Public Comments on Eldridge

The Title of the HDD Re-Evaluation Report is “**Eldridge Drive/North Chester Road Crossing**” which appears to reference two different drill site locations in East Goshen Township, PA. Further, the attached HDD Hydrogeologic Re-Evaluation Report, prepared by GES, simply refers to the location being evaluated as “S3-500 North Chester Road” and makes no reference by name to Eldridge Drive whatsoever. At a recent public meeting in East Goshen Township on September 19, 2019 a map bearing the Energy Transfer logo was presented to the Township Supervisors and audience, and referenced by Energy Transfer representatives, which clearly illustrated one drill site location labeled as Eldridge Drive HDD 500 (20”) and a separate drill site location labeled as North Chester Road HDD 521 (16” & 20”). If the First Report is only referencing the Eldridge Drive location it should be simply and clearly labeled as such. Although maps provided in the attached GES document show what appears to be the Eldridge Drive location, the name of their report clearly refers to an entirely different drill site location.

WATER RESOURCES

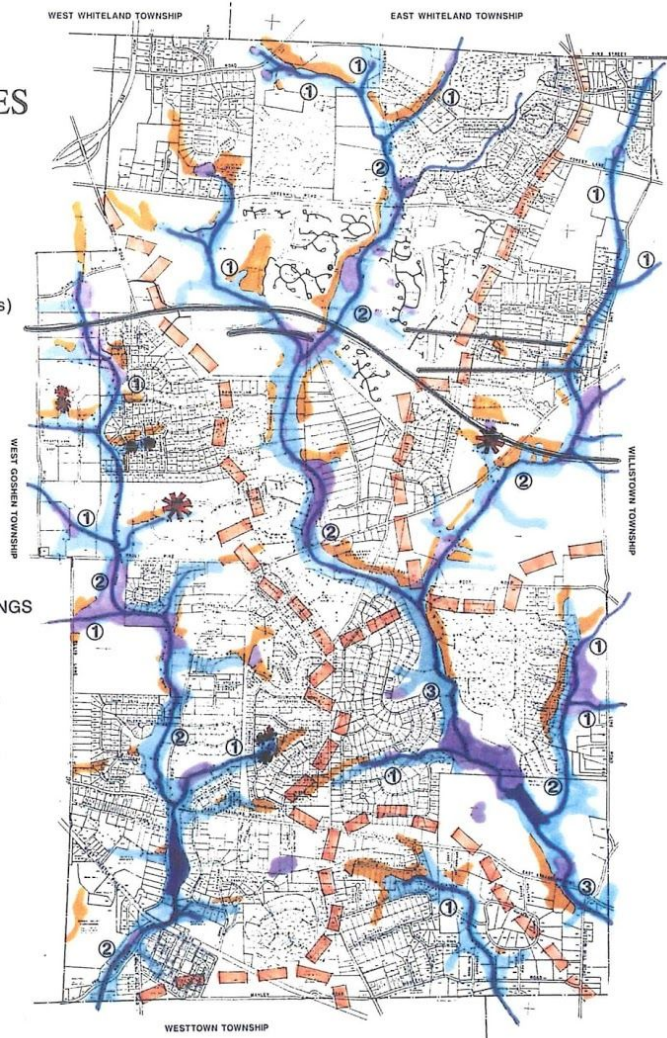
The report also states that “A 100 year floodplain encompasses each of East Goshen’s two waterways. 100-year floodplains are areas that adjoin streams, ponds, or lakes which are subject to inundation by 100-year floods. Floodplain areas are important considerations because they carry the floodwaters that pose potential threats to lives and property. Development in and around these areas may reduce water quality and increase erosion, as well as threatening wildlife and their habitats. The 100-year floodplains are shown on the accompanying map.”

This is important because **no reference is made to the adjacent floodplain risks** in the Operator’s report of *Adjacent Feature Analysis* and the operator has offered no solutions to mitigate the risks of pipeline development, increased erosion, threats to the public, property, or wildlife and habitat.

RECOMMENDATION: The “Adjacent Feature Analysis” is incomplete in insufficient. The DEP should not allow development in an area with 21 fracture traces, floodplain risk, substantial nearby wetlands and watersheds. No permit should be issued for work in this area.
